Bracket, Door Harness, Replacement

M-831-001

All Mack MR, TE Trucks built with heated mirrors

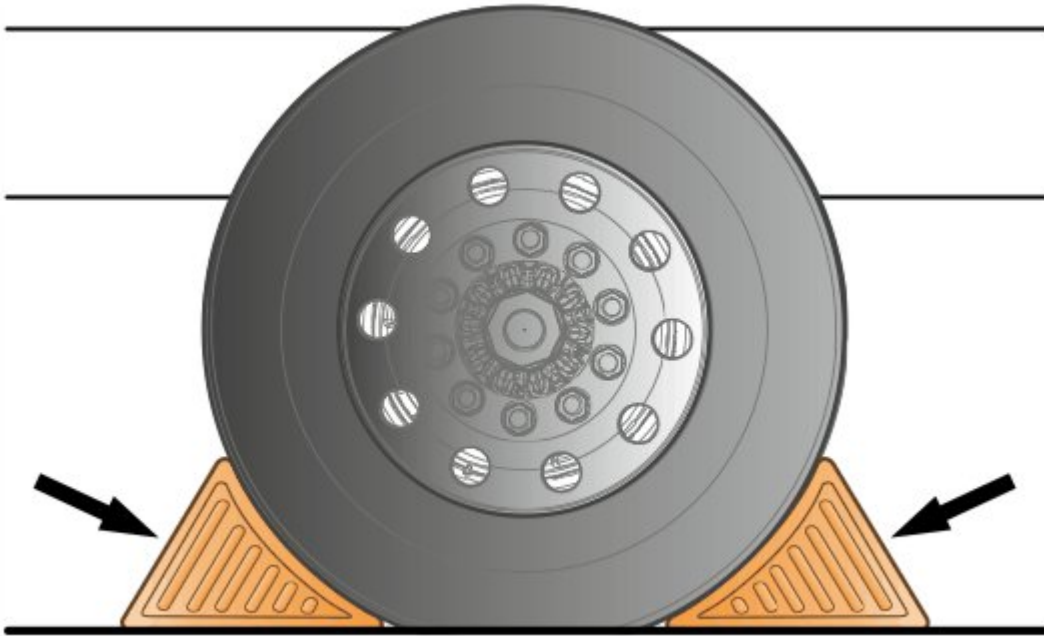
Certain Mack MR, TE trucks could experience breakage of the heated mirror cable at the bottom of the door where it goes through the clamps. In certain instances, it is possible for the door to pinch the harness at the clamp causing damage to the harness. A new bracket has been developed to secure the harness in a way that stops binding and pinching. Follow the instructions outlined in the document to remove the old clamps, Install the new bracket and reroute the heated mirror cable.

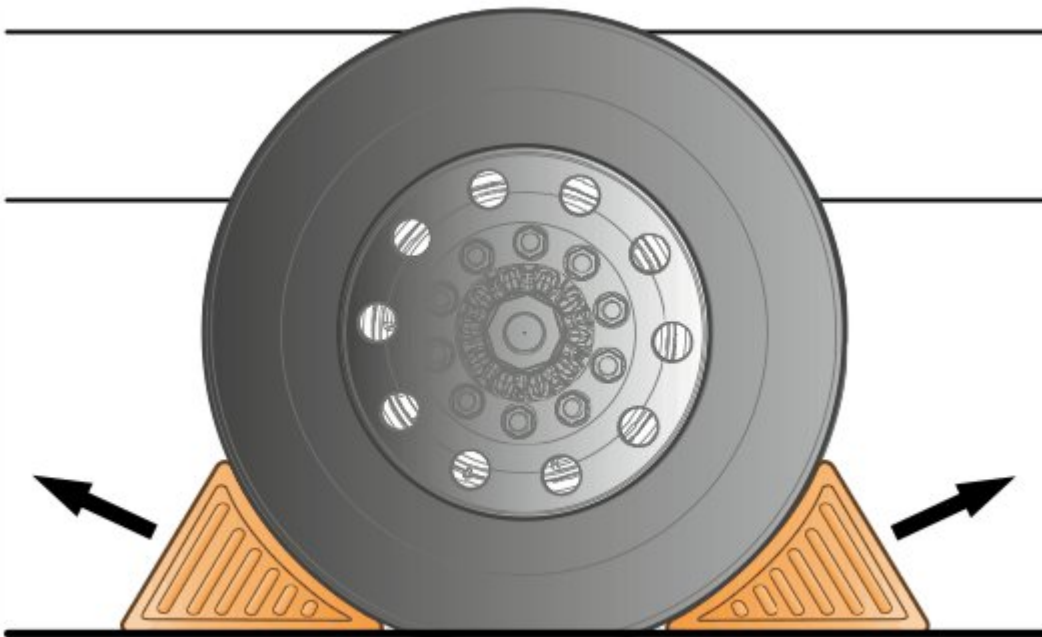
- . If the heated mirror cable is damaged replace it with new one following Impact.
- . Using two cable ties 948211 to secure the cable to the bracket.
- . Operate the door and verify the cable is not binding or pinching in any way.
- . Repeat the process for the passenger door if applicable.
- . Connect the cable to the negative terminal.
